## **AGENDA ITEM 4A**

**Planned Unit Development – Lots 23-26 Southport  
West and portions of Lot 1 Southport West Replat  
Four – Southport West Partners, LLC**

**CITY OF LA VISTA**  
**PLANNING DIVISION**  
**RECOMMENDATION REPORT**

RE: Planned Unit Development Amendment – Initial Review Letter  
Lots 23-26 Southport West and Lot 1 Southport West Replat Four

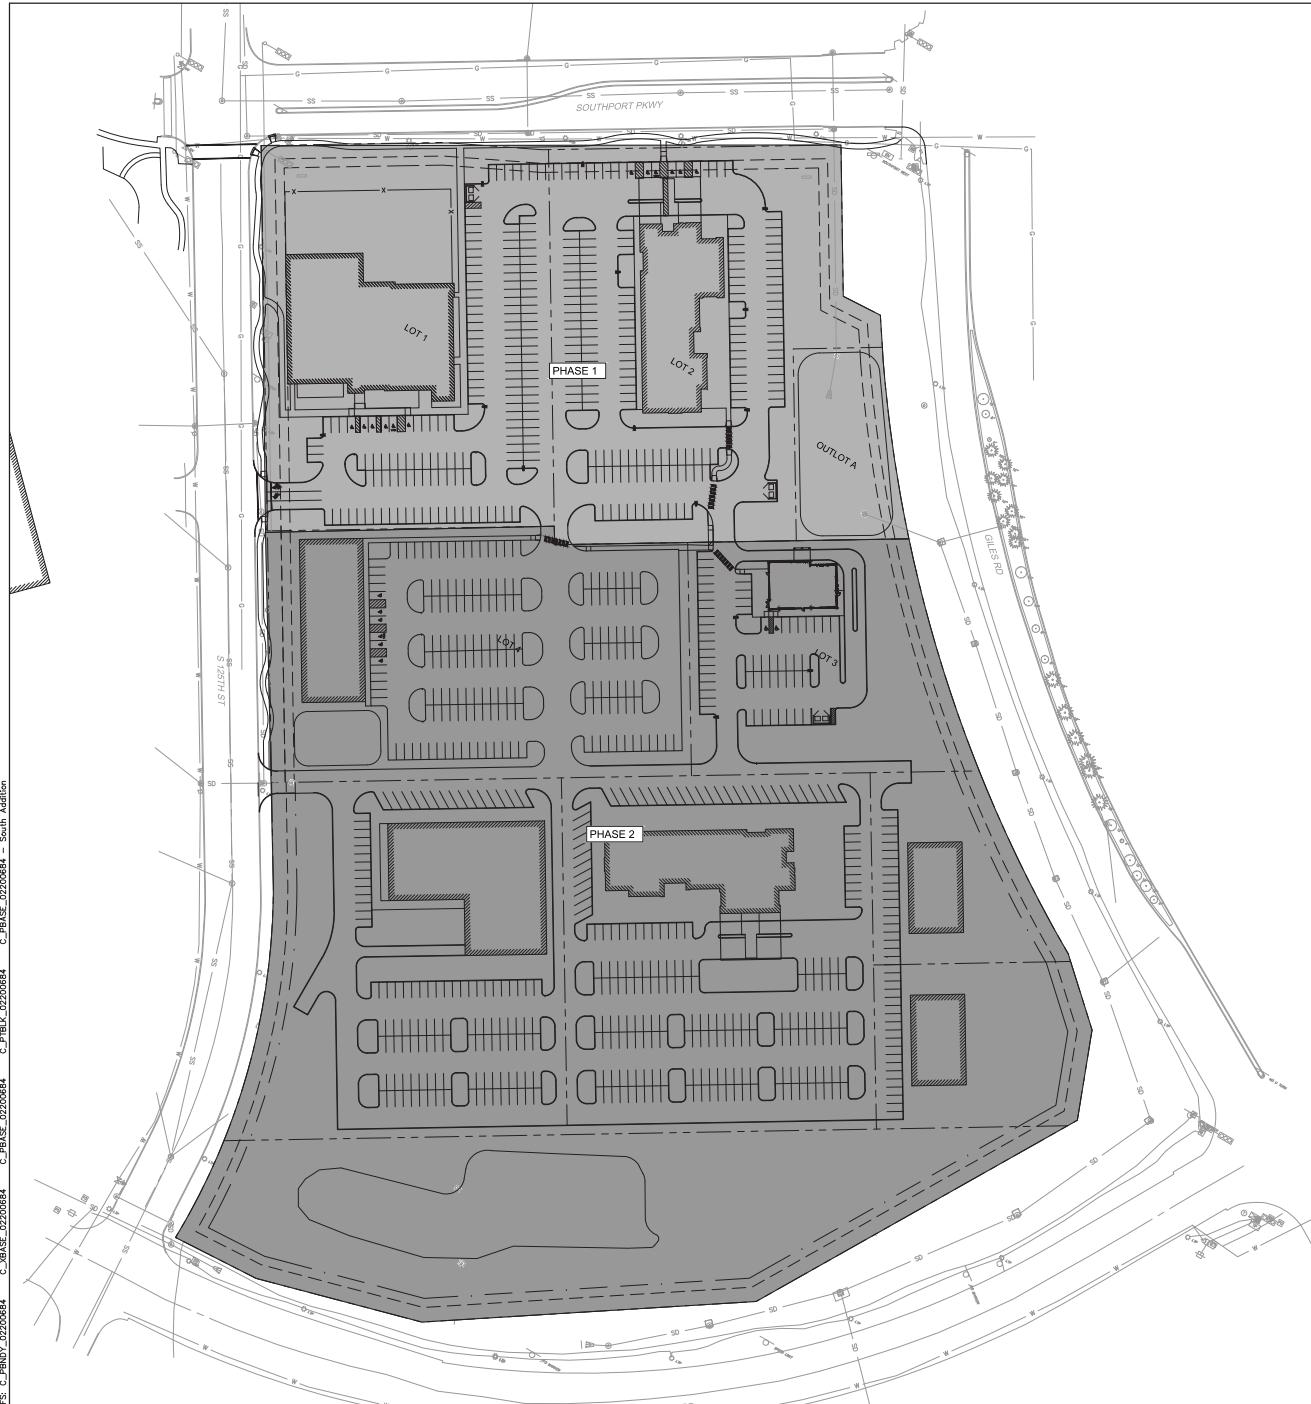
1. As discussed in the pre-application meeting, in an effort to push the northern two lots through the process as quickly as possible, the PUD plan set should concentrate on only the development of the northern two lots. Except for sheet C3.0, the PUD plan set should not include the site design below the southern lot line of lots 2 and 3.

Please revise the title of sheet C3.0 to "Conceptual PUD Phasing Plan" and change the phasing to only include lots 2 and 3 in Phase 1.

**Response: Per discussions, the plans have been revised to reflect the design for the north 2 lots only and phasing clarification has been updated accordingly.**

Figure 16. Recommended Improvements

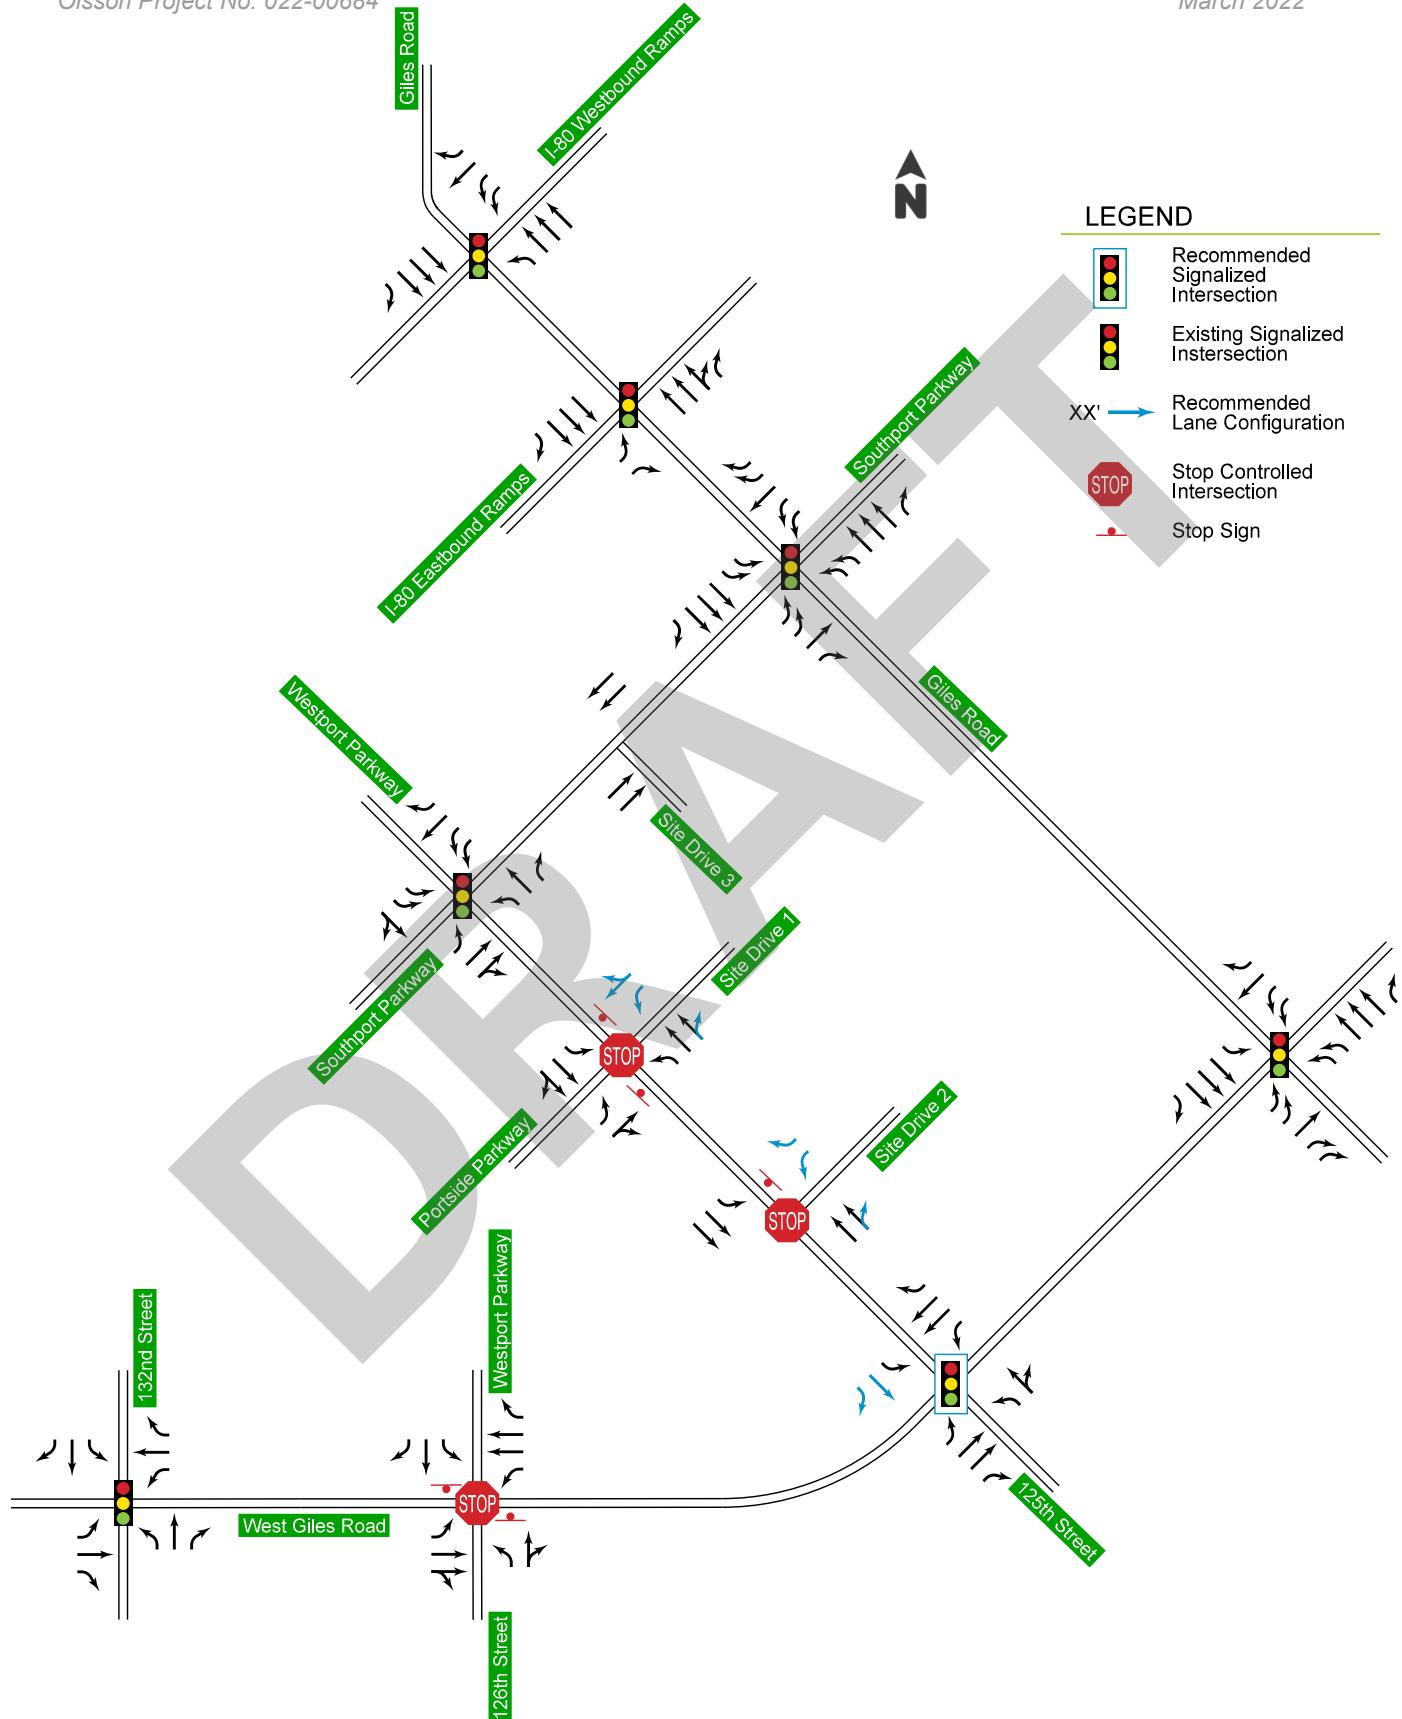
In addition to the above recommendations, during overflow parking conditions for Lot 3 in the proposed development, pedestrians crossing 125<sup>th</sup> Street / Westport Parkway from the parking lot to the west of the site should be monitored to determine the need for higher visibility pedestrian crossing applications like the RRFB or HAWK beacon systems at a midblock location. Recommended improvements are summarized in **Figure 16**.
